Submissions table – Ōpāwaho Heathcote River Planting Plan, June 2025

Organisations / Businesses

Area 3: Centennial Park

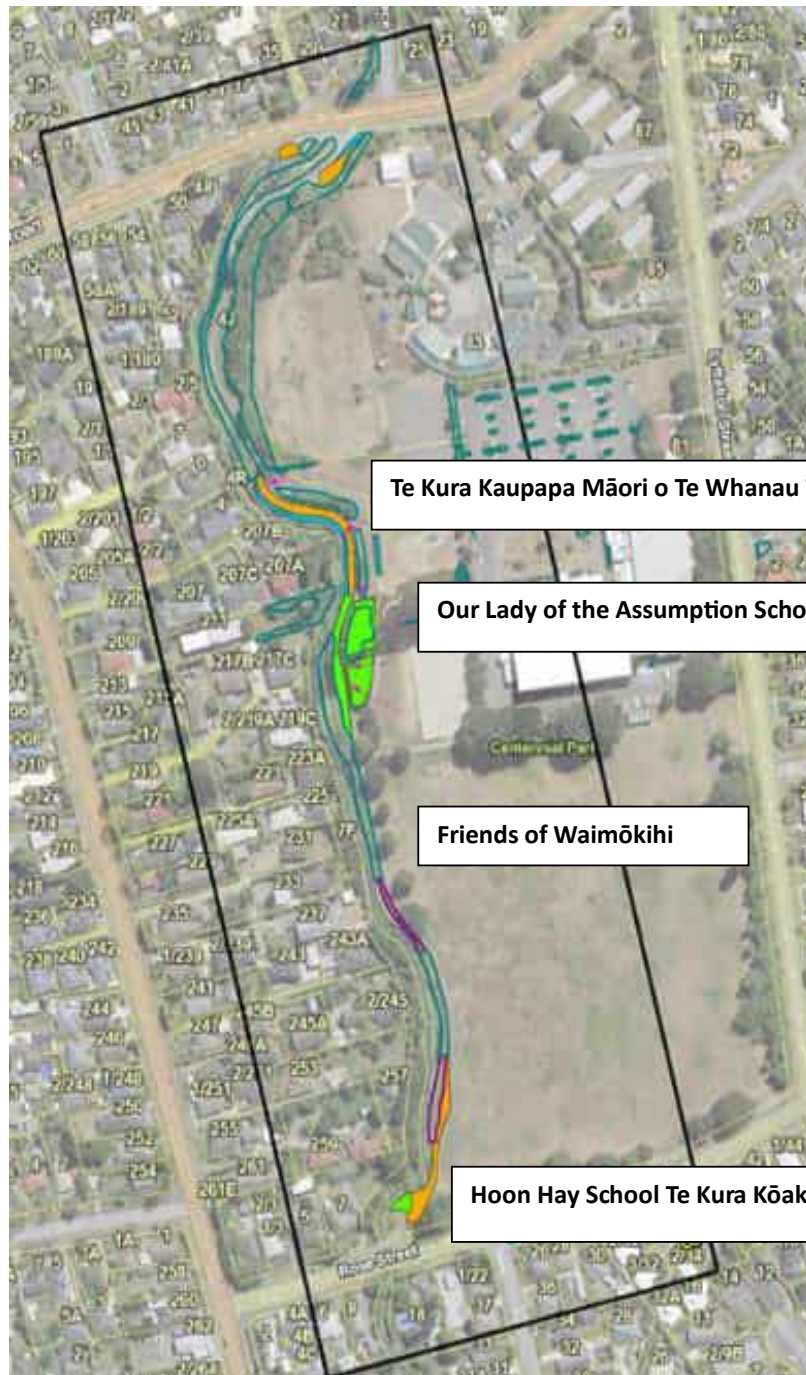
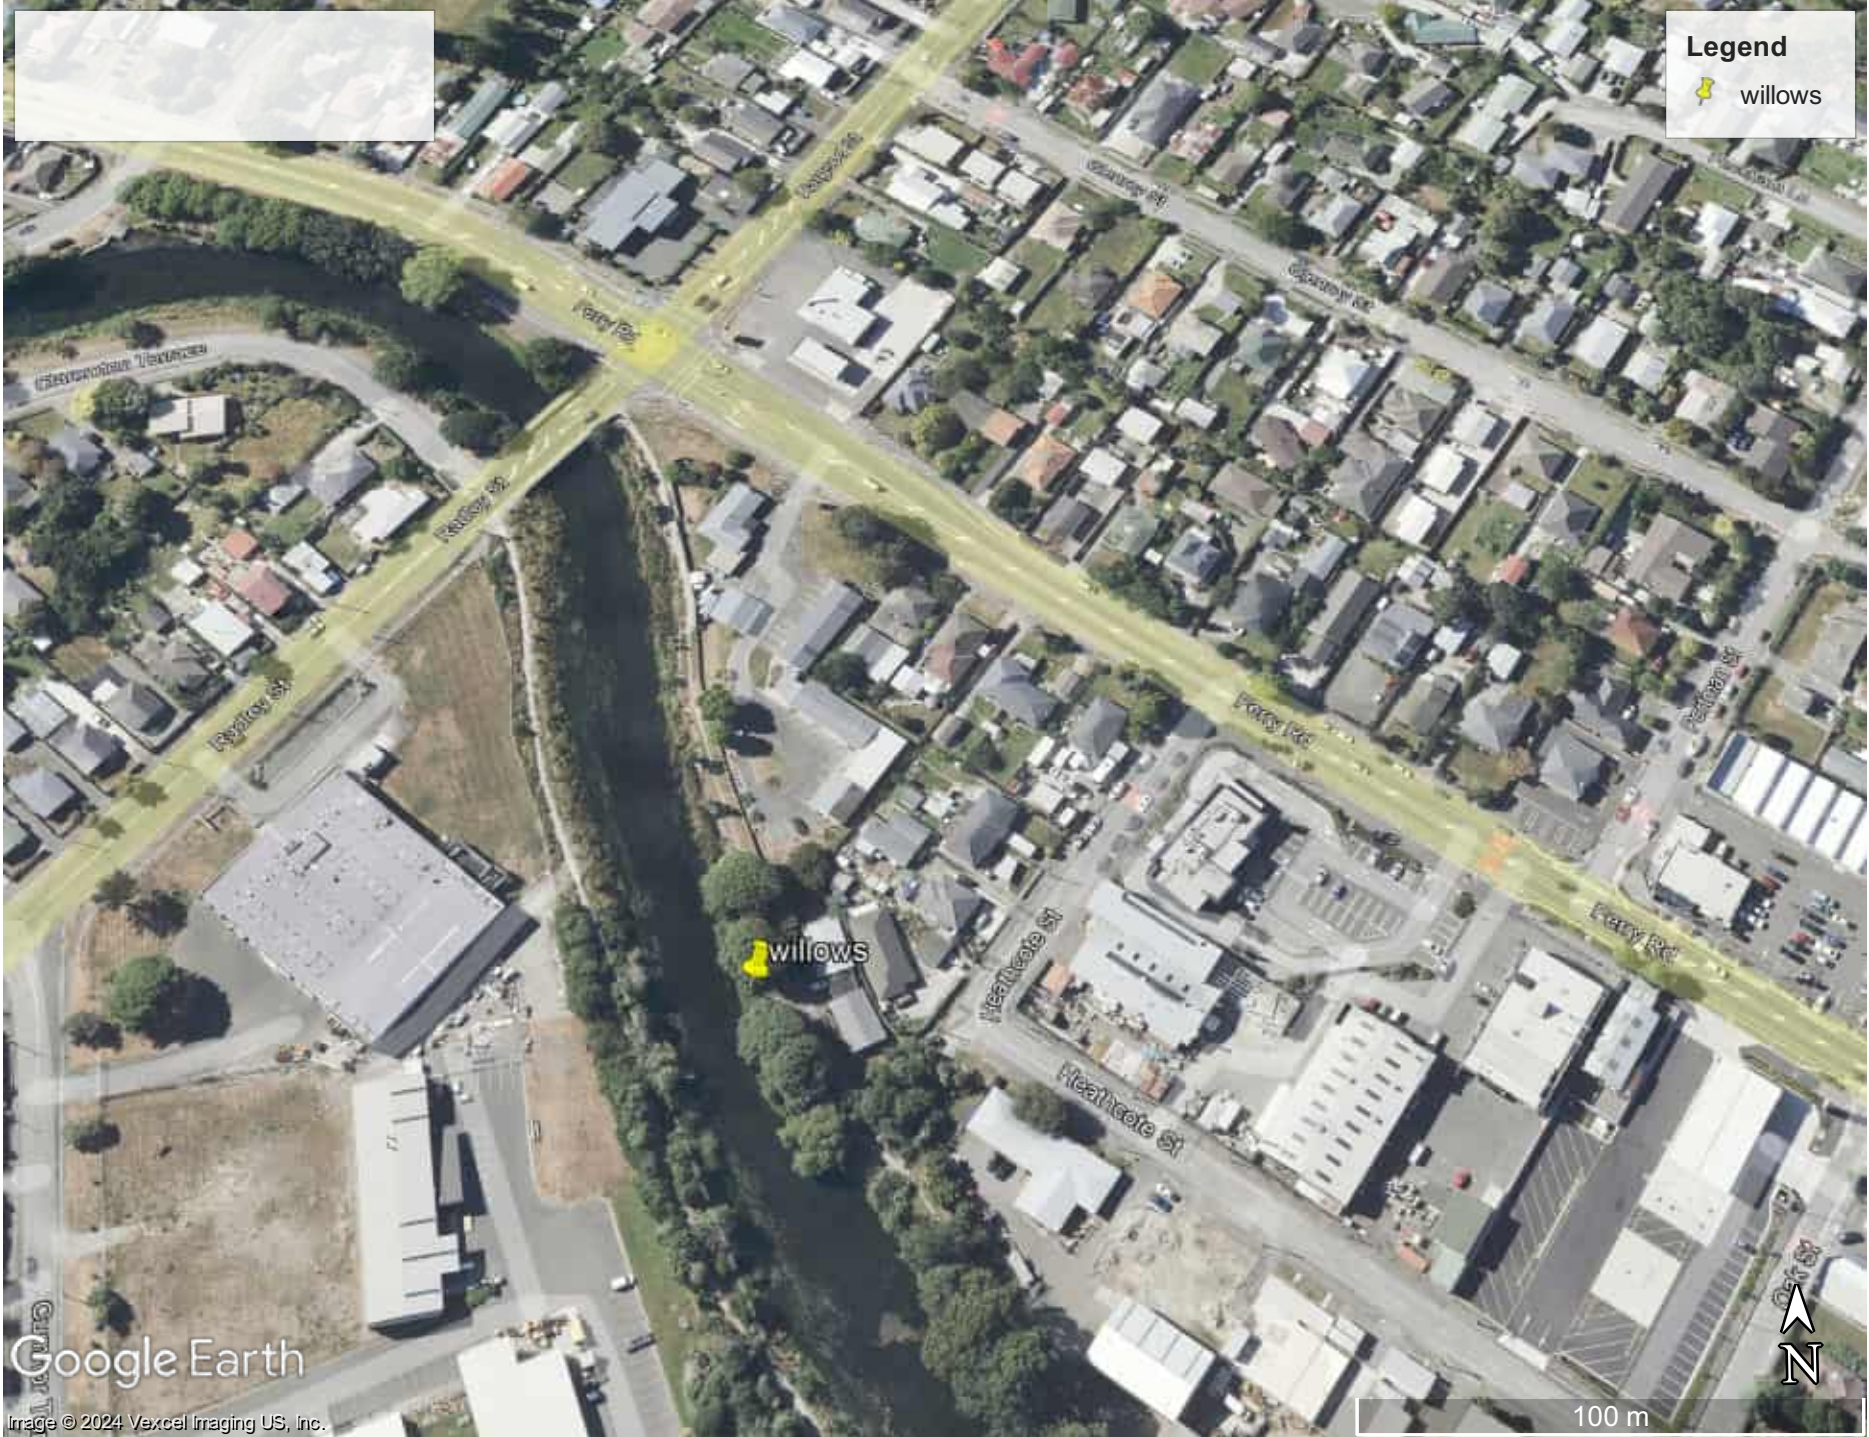
35590	Do you support this river planting plan, the areas outlined and the guideline? Yes Tell us why you feel this way Our church community is highly invested in caring for the river, increasing biodiversity and establishing a flourishing environment for people, plants and animals. This plan is a big step in that direction. Do you have any more feedback about river planting areas or the guideline? The guidelines look great. Make sure to include a range of plants along the whole river to nurture bio-diversity.	The River Ōpāwaho, James Beck
35762	Do you support this river planting plan, the areas outlined and the guideline? Yes Tell us why you feel this way It allows our group to continue maintaining and inter-planting in our existing restoration area - and provides opportunities to facilitate further planting in Area 3 Do you have any more feedback about river planting areas or the guideline? Re Area 3 Background - There are four groups which have restoration areas in Centennial Park (see attached plan) - Friends of Waimōkihi - Our Lady of the Assumption School Te Kura o Tūpaki - Hoon Hay School Te Kura Kōaka - Te Kura Kaupapa Māori o Te Whanau Tahī Friends of Waimōkihi take an occasional role in coordinating with the three school Friends of Waimōkihi have monthly work days, most of which focus on maintaining existing plantings. In winter, in consultation with the CCC Ranger, additional plants are planted within existing areas. The three schools have occasional maintenance sessions, usually in liaison with the CCC rangers. <u>Feedback from Friends of Waimōkihi</u> We support the removal of willow trees, and replacement with clear-trunked canopy trees at 8m spacing. We will work with the Council arborist and rangers to facilitate this. In the area we maintain we have retained sightlines to the river, and will ensure the sightlines indicated on the Area 3 plan are also established and maintained.	Friends of Waimōkihi restoration group (Centennial Park), Miria Goodwin
